Access Compliance Report

Public Rights-of-Way

Intersection ID: 42492	Main Street: ALMA_BLOUNT_BV	Cross Street: JAMES_BLAKENEY_AV	Location: E
ADA ID: 60EE94B64393	Ramp Type: PerpDiag	Initial Pass/Fail: Fail	Overall Compliance: No
Severity Score: 12.5			
Codes/Mitigation Info/Possible Solution		Field Measurements/Component Compliance

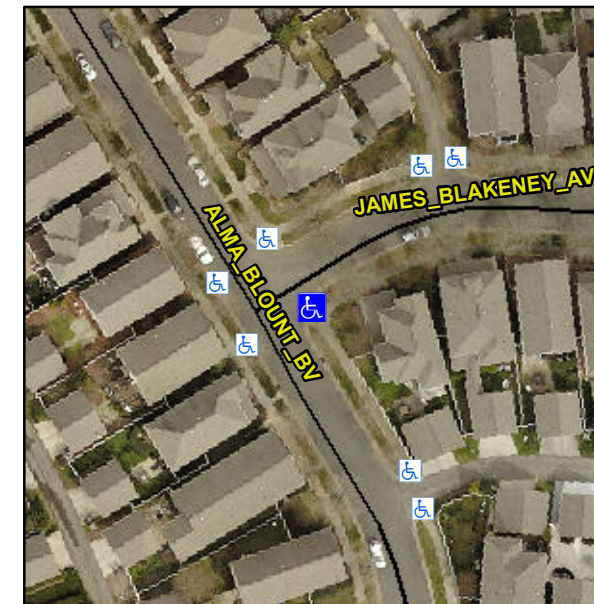
Remove & Replace Curb Ramp With Two New Directional Ramps or Equivalent.

Not Found, R304.2.2

Compliance	Description	Data	Compliance	Description	Data
N/A	Ramp Length (in)	77.0	No	Ramp Slope (%)	9.5
Yes	Ramp Width (in)	57.0	Yes	Ramp XSlope (%)	0.2
N/A	Flare Type LT	N/A	N/A	Flare Type RT	N/A
N/A	Flare Slope LT (%)	N/A	N/A	Flare Slope RT (%)	N/A
N/A	Flare Traversable LT?	N/A	N/A	Flare Traversable RT?	N/A
N/A	Landing Length (in)	N/A	N/A	DWS Provided?	N/A
N/A	Landing Width (in)	N/A	N/A	DWS Contrast?	N/A
N/A	Landing Slope (%)	N/A	N/A	DWS Length (in)	N/A
N/A	Landing X Slope (%)	N/A	N/A	DWS Full Width?	N/A
N/A	Landing Curb? (Y/N)	N/A	N/A	DWS Offset (in)	N/A
N/A	Shared Landing?	N/A			
N/A	Gutter Ponding?	N/A	N/A	Gutter Slope (%)	N/A
N/A	Gutter Lip Ht (in)	N/A	N/A	Gutter X Slope (%)	N/A
N/A	Painted X Walk1?	No	N/A	Painted X Walk2?	No
	X Walk 1 Direction	To NW		X Walk 2 Direction	To SW
N/A	X Walk 1 Width (in)	N/A	N/A	X Walk 2 Width (in)	N/A
	X Walk 1 Slope (%)	2.2		X Walk 2 Slope (%)	2.2
	X Walk 1 X Slope (%)	0.4		X Walk 2 X Slope (%)	1.1
